TECHNICAL INFORMATION BULLETIN

T1200 Spare Motherboard Software Issues

Figure 1 – Location of Software label and PCB Reference

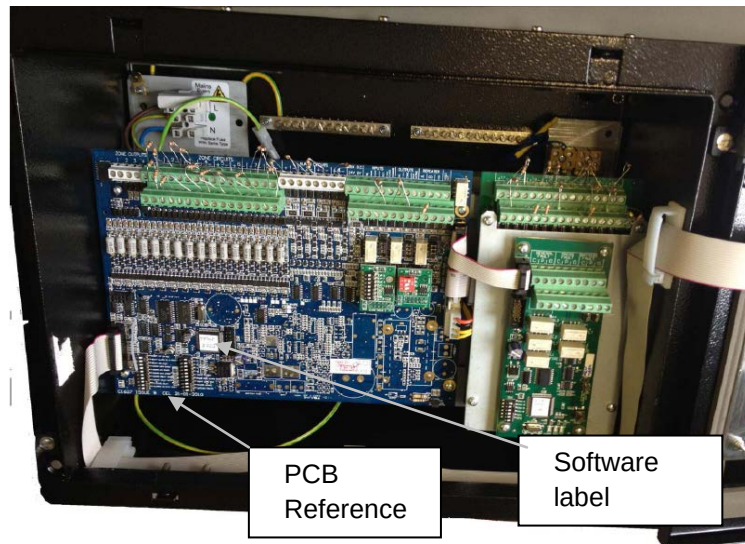
- At ordering stage, check software version and PCB reference on existing panel motherboard. [See Fig 1 below]. The order for the spare board should specify the PCB reference and the software reference.
- Prior to installation, check software version and PCB reference on existing panel motherboard and replacement PCB. They should be the same.
- Any T1200 panel which has had the motherboard replaced since 4th Oct 2012:
 - The system test records covering the replacement work should be rechecked. Where the records do not allow verification of the configuration and testing of the Crew Mode feature or, where

- At ordering stage, check software version and PCB reference on existing panel motherboard. The order should specify the software reference. [See Fig 1 below].

- Prior to installation, check software version and PCB reference on existing panel motherboard and replacement panel. They should be the same.
- Any existing T1200 panel programmed with PRENPB** or PRENPZ** which since 4th Oct 2012 has been replaced with a T1200 panel programmed with T1200PB00/T1200PZ00:
